SUBJECT: TECHNICAL REVIEW: PERFORMANCE OF THE HIGH DENSITY
POLYETHYLENE LAYER, HIGH DENSITY POLYETHYLENE/
GEOSYNTHETIC CLAY LINER COMPOSITE LAYER, AND THE
LOWER LATERAL DRAINAGE LAYER (DOCKET NO. PROJ0734)

The U.S. Nuclear Regulatory Commission (NRC) staff has performed a technical review of the performance of the High Density Polyethylene (HDPE) layer, HDPE/Geosynthetic Clay Liner (GCL) composite layer, and the Lower Lateral Drainage Layer (LLDL) as part of NRC monitoring of U.S. Department of Energy (DOE) disposal actions at the Savannah River Site (SRS) Saltstone Disposal Facility (SDF).

**Technical Review of Performance of the High Density Polyethylene Layer,
High Density Polyethylene/Geosynthetic Clay Liner Composite Layer,
and the Lower Lateral Drainage Layer**

Figure 6: Fraction of Infiltration Shed Through the LLDL of the Various Disposal Structure Types
(Adapted by NRC from the PORFLOW Model Files for the Evaluation Case in SRR-CWDA-2014-00006, Rev. 2)

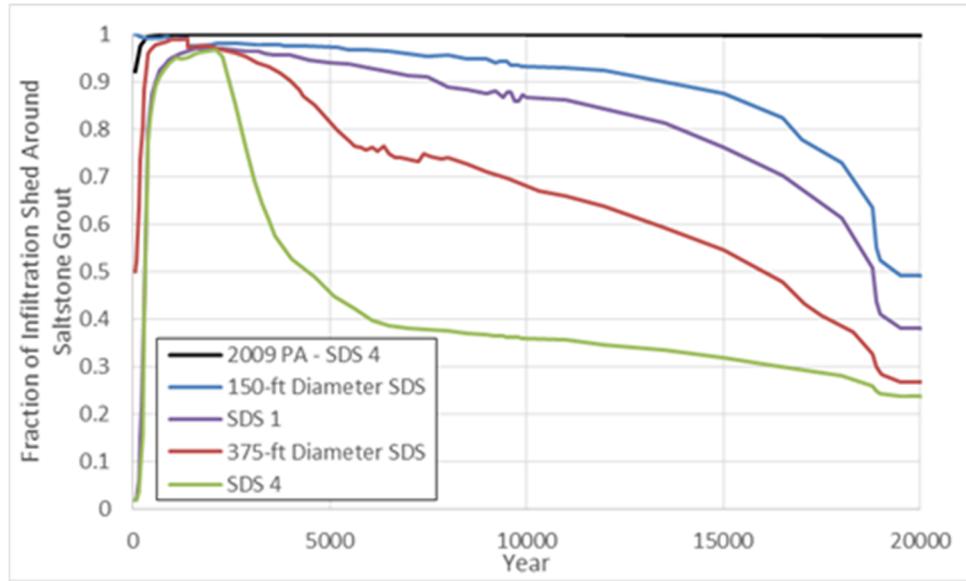
Due to the increased degradation of the HDPE/GCL composite layer simulated in both the FY 2013 and FY 2014 Special Analysis Documents, around 1,400 years after closure the amount of water flowing through that composite layer and the salt wasteform below increases. Consequently, the amount of water being diverted around the wasteform within the LDL would be expected to go down. However, as data compiled by the NRC staff from the PORFLOW model files illustrates in Figure 6, the amount of water being shed was still a significant portion of the overall infiltration that made its way through the engineered cover. Even after 10,000 years, the proportion of infiltrating water not flowing through the wasteform in a 375-Foot Diameter Disposal Structure was greater than 65% and the proportion not flowing through the wasteform in a 150-Foot Diameter Disposal Structure was greater than 90%. Because there were several barriers acting in series (e.g., LDL, roof, saltstone), the contribution from individual barriers to that shedding is not clear to the NRC staff.

overlying sand after 1,400 years, and the floor HDPE/GCL was considered to be fully degraded to backfill at the end of 1,400 years. In the NRC 2012 SDF TER, the importance of the LDL as a barrier together with the roof HDPE/GCL and the concrete roof was recognized. The NRC staff notes that even after the accelerated degradation rates had been implemented for two of those three barriers (i.e., HDPE/GCL composite layer, concrete roof), the LDL was still modeled as diverting most of the infiltrating water away from a 375-Foot Diameter Disposal Structure, which allowed less than 35% of the available water to flow through the wasteform within the first 10,000 years (see Figure 6 above).

Figure 7: Hydraulic Conductivities of the HDPE Layer and HDPE/GCL Composite Layer after Closure as used in the Models for Both the DOE SDF FY 2013 and FY 2014 Special Analysis Documents (Figure AI 14-2 in SRR-CWDA-2016-00004, Rev. 1)

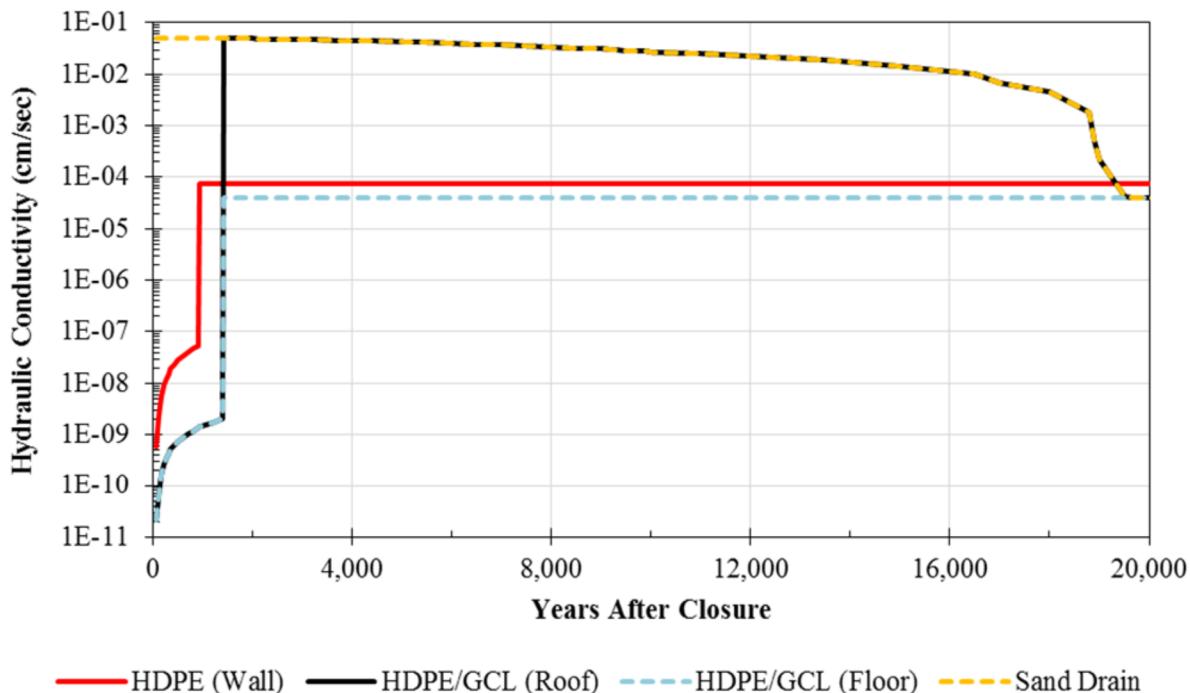
In the PORFLOW model in both the DOE SDF FY 2013 and FY 2014 Special Analysis Documents, the hydraulic conductivity of the wall HDPE in the 150-Foot Diameter Disposal Structures changes abruptly to a value similar to backfill at 900 years, while the roof HDPE/GCL was considered to behave like the overlying sand after 1,400 years. Since the hydraulic conductivity of the one-inch modeled HDPE/GCL composite layer is equivalent to that of the LDL after that point-in-time, the values of the one-inch modeled HDPE/GCL composite layer were linked with that of the LDL. As clay accumulated in the sandy LDL, the properties of the one-inch modeled HDPE/GCL composite layer also changed and reflected the sand's transition

In models in both the FY 2013 and FY 2014 Special Analysis Documents, the HDPE hydraulic conductivity at the wall changed from 5×10^{-15} cm/s to 4×10^{-5} cm/s at 900 years and the HDPE/GCL hydraulic conductivity at the roof changed from 5×10^{-15} cm/s to 5×10^{-2} cm/s at 1,400 years. The DOE basis for the abrupt change in the modeled HDPE/GCL properties for the evaluation case in both Special Analysis Documents was that the degradation of those barriers must occur prior to the diffusion of carbon dioxide (from the soil) for degradation by carbonation, or degradation of concrete by decalcification. The DOE indicated that modeling abrupt failure of the HDPE layer and HDPE/GCL composite layer allowed the performance of the HDPE layer, HDPE/GCL composite layer, and both the 150-Foot Diameter and 375-Foot Diameter Disposal Structures to be better assessed.

While the NRC appreciates the DOE effort to begin simulating degradation processes earlier to observe the modeled effect on contaminant movement, the DOE conceptual model of the disposal system is now significantly different than what was presented in the DOE 2009 SDF PA. The technical bases for the expected performance of the HDPE layer and HDPE/GCL composite layer were documented in WSRC-STI-2007-00184, Rev. 2, WSRC-STI-2008-00244, Rev. 0, and supporting documents. The NRC evaluation of those DOE documents was documented in the NRC 2012 SDF TER. Although the models of the HDPE layer and HDPE/GCL composite layer sudden degradation after several hundred years in both the DOE SDF FY 2013 and FY 20134 Special Analysis Documents may be more conservative than the model in the PA, it is not clear to the NRC that the model will consistently be fully supported or conservative for all reasonably foreseeable circumstances and cases. Barrier performance could be obscured in PA sensitivity cases due to the temporal and spatial variability of possibly many processes and events affecting the performance a barrier and due to the redundancy of barriers where the potential performance of one barrier at a particular time may not be revealed due to the effectiveness of another barrier at that time.

**Figure 8: Pressure Head at Time 1,265 Years to 1,400 Years for
a 375-Foot Diameter Disposal Structure Cross Section
(Video File “SDU6_Flow_PressureHead.avi” in SRR-CWDA-2016-00060, Rev. 0)**

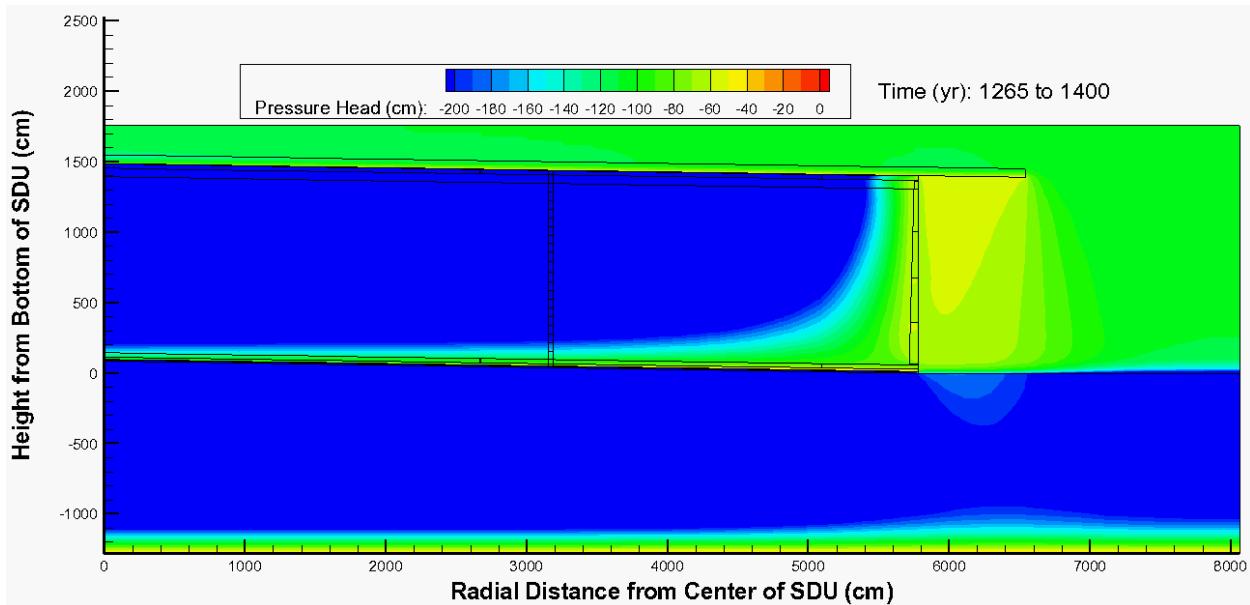
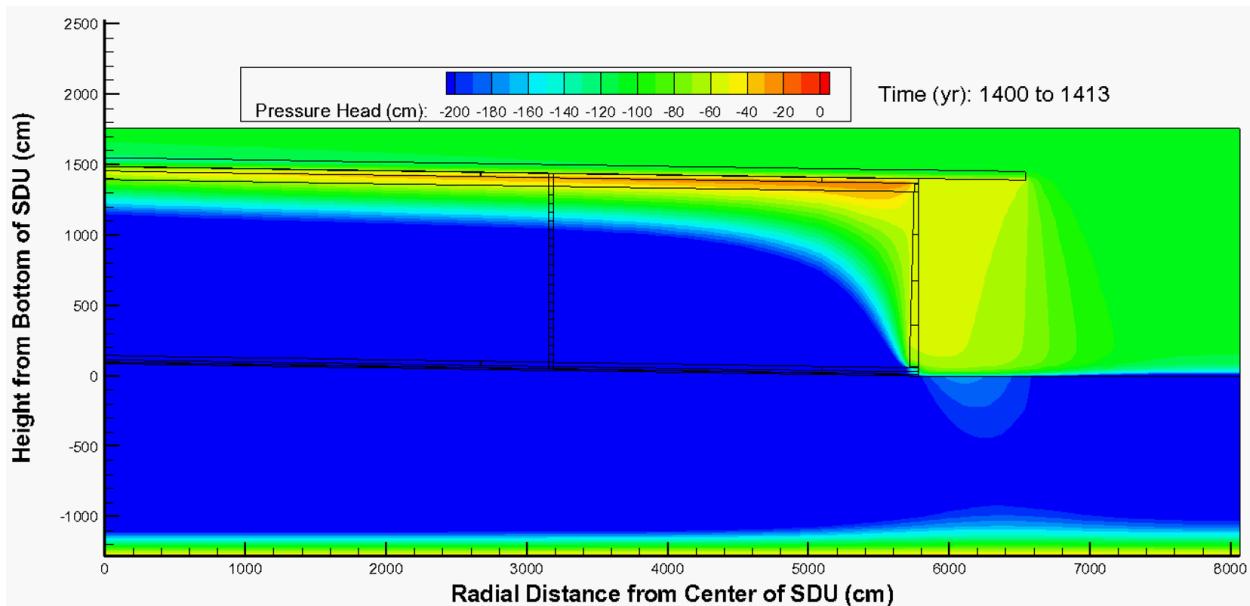
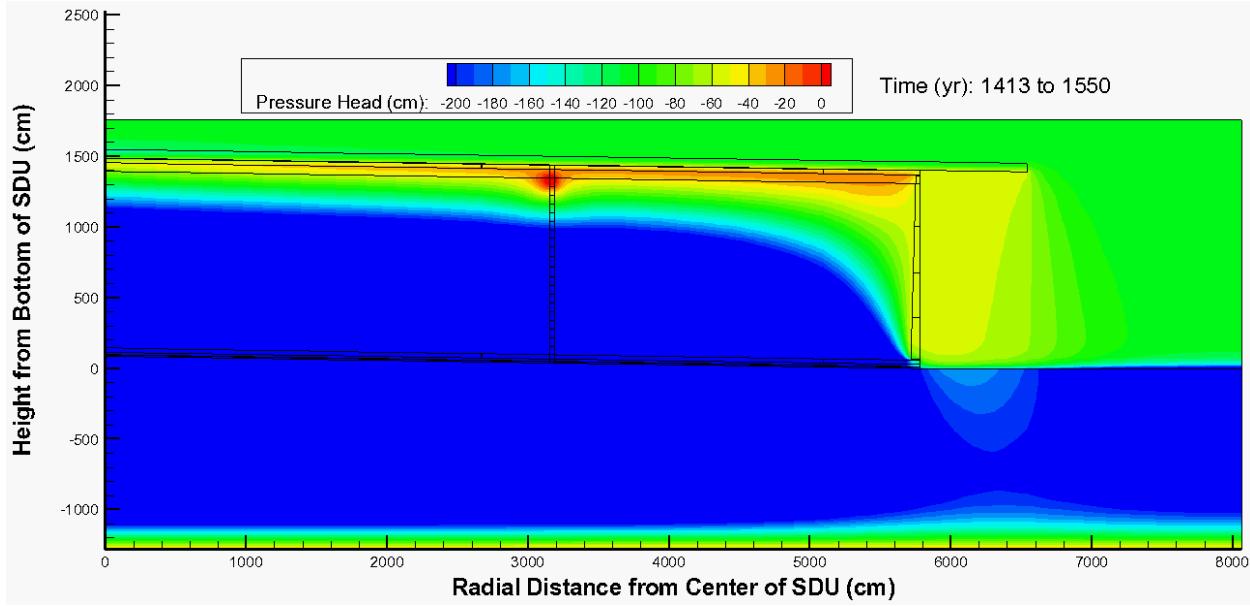
By the DOE changing the original hydraulic properties of the HDPE/GCL composite layer to that of a sandy drainage layer, the modeled thickness of the LLDL increased from 12 in to 13 in. The one-inch thick model layer that impeded flow with a lateral hydraulic conductivity value of 5×10^{-15} cm/s then switched to promoting lateral flow with a hydraulic conductivity value of 5×10^{-2} cm/s. The changes to the hydraulic regime of a 375-Foot Diameter Disposal Structure is shown in both Figure 8 and Figure 9 below with PORFLOW vertical cross-sections of pressure heads before and after 1,400 years. The differences shown between Figure 9 and Figure 10 below are due to the changing properties of the underlying cementitious materials among other degradation processes.

Another example of potential performance being obscured due to the complexity and interdependencies of the system was previously discussed in the Background Section of this Technical Review Report (TRR). The NRC 2012 SDF TER had presented a hypothetical conceptual model where the HDPE layer performed better than expected so that the saltstone could substantially oxidize due to gas-phase transport of oxygen, while being exposed to very little water. If the HDPE layer were then to begin to fail suddenly several thousand years after placement, then the oxidized saltstone could quickly be exposed to a relatively sudden flow of water that could cause the release of contaminants in a relatively short amount of time.

**Figure 11: Flow Direction at Time 1,265 Years to 1,400 Years
Through a Disposal Structure Floor
(Figure CC-1.20 in SRR-CWDA-2016-00004, Rev. 1)**

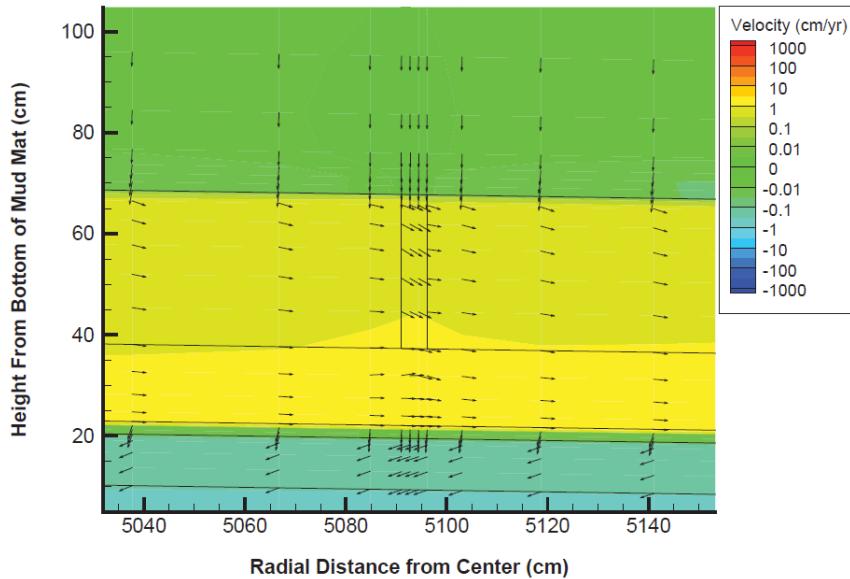
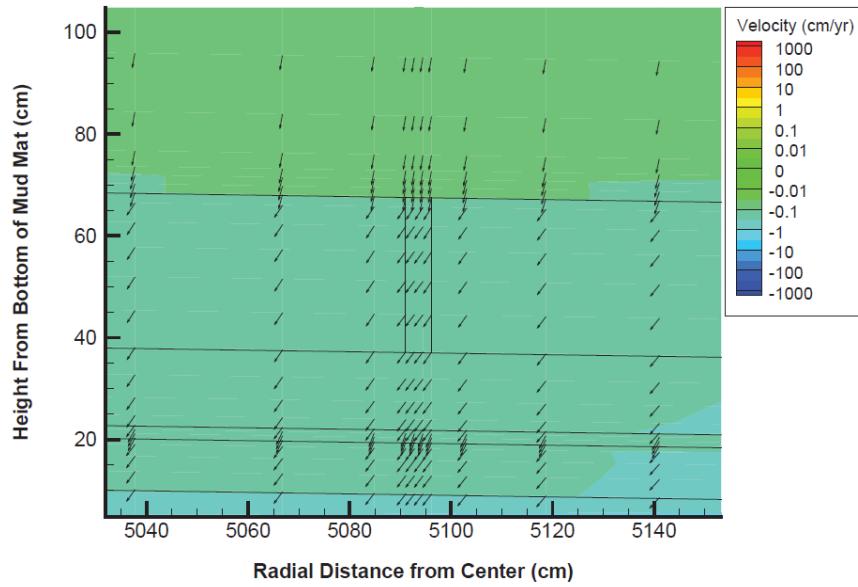
Flow in and through the floor was also considerably changed in the year the HDPE/GCL composite layer was modeled as failing. Both Figure 11 and Figure 12 below show flow moving laterally toward the sides of the wasteform, while immediately after 1,400 years, water was modeled as flowing out of the bottom of the wasteform, thereby, potentially changing the location and concentration of a plume.
